BURNS AND ROE, INC.
WPPSS
NUCLEAR PROJECT
NO. 2

PROJECT
ENGINEERING
DIRECTIVE

This PED is for the preparation of the partial penetration weld joint to be used on the sac. wall at 541'-5" el..

SUBJECT Sac. Shield Wall Welds
LOCATION 541'-5" All A
ENG. SYSTEM N/A
S/U SYSTEM N/A
QUALITY CLASS I

PLAN (T.O.S. EL. 541'-5)

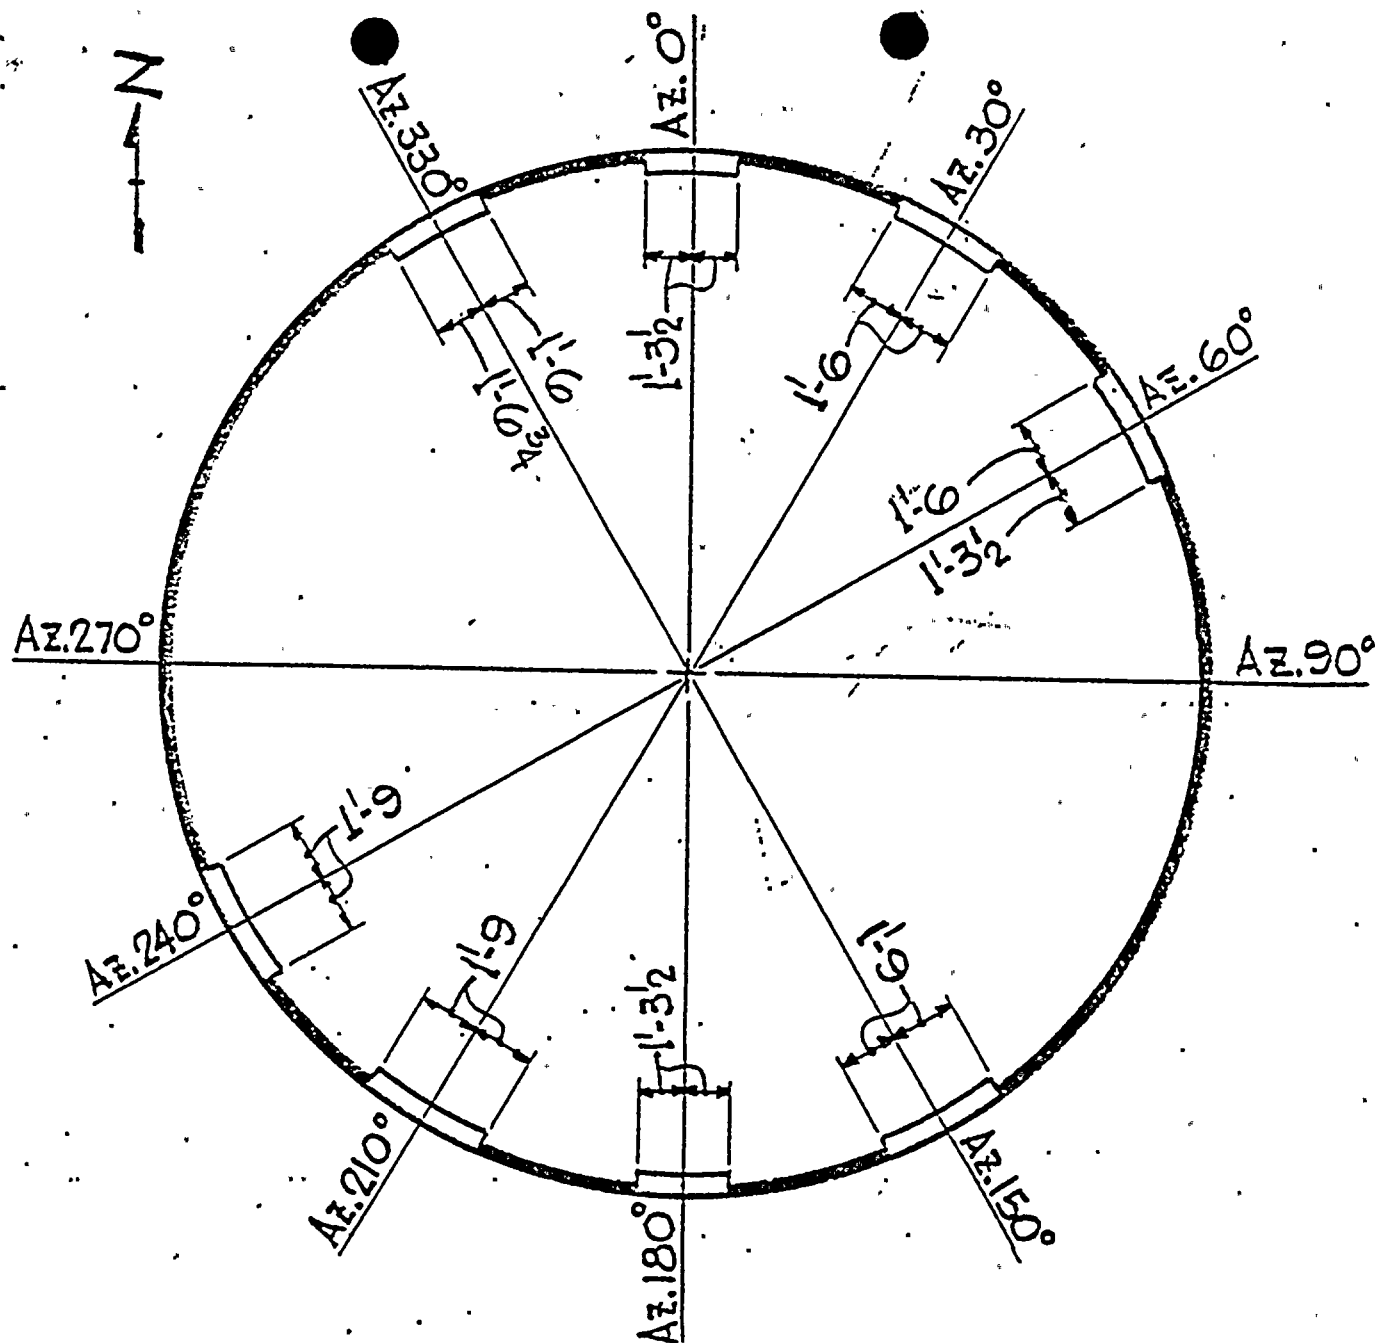
— SHADED AREAS INDICATE 1 1/2" THK. SIDE PL. ON BUILT-UP MEMBER ③

□ UNSHADED AREAS INDICATE 3" THK. SIDE PL. ON BUILT-UP MEMBER ③

TYPICAL WELD PREPARATION WHERE
LEDGE IS LESS THAN 1" WIDE & SIDE
R. / BUILT-UP MEMBER ③ IS 3"

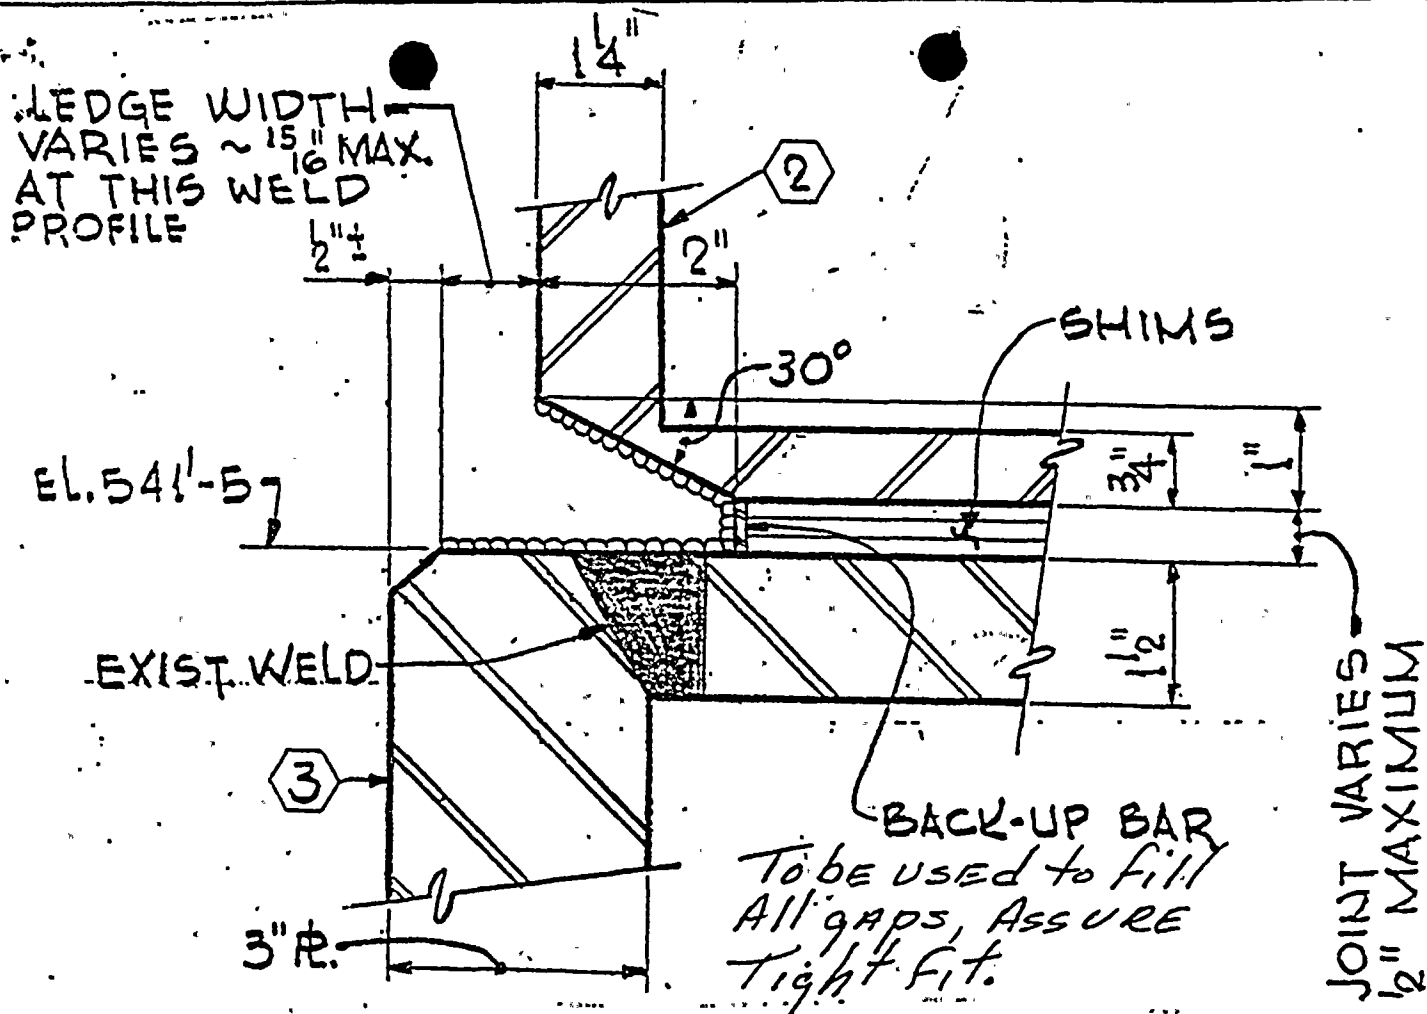
- NOTE:
- 1) Insure proper preheat of $200^{\circ}\text{F.} \pm 25^{\circ}\text{F.}$ with $1\frac{1}{2}$ hrs. soak time prior to air arc-gouging joint preparation.
 - 2) Clean and grind after air arc-gouging to a visual acceptance per AWS D1.1 prior to welding.
 - 3) Joint preparation shall have a minimum root gap of $3/8"$ with installation of backing where open root exist.
 - 4) Complete I.D. of weld joint shall be buttered with SMAW E7018 process prior to welding.
 - 5) Existing column splice welds shall not be removed, only beveled to make joint preparation acceptable.
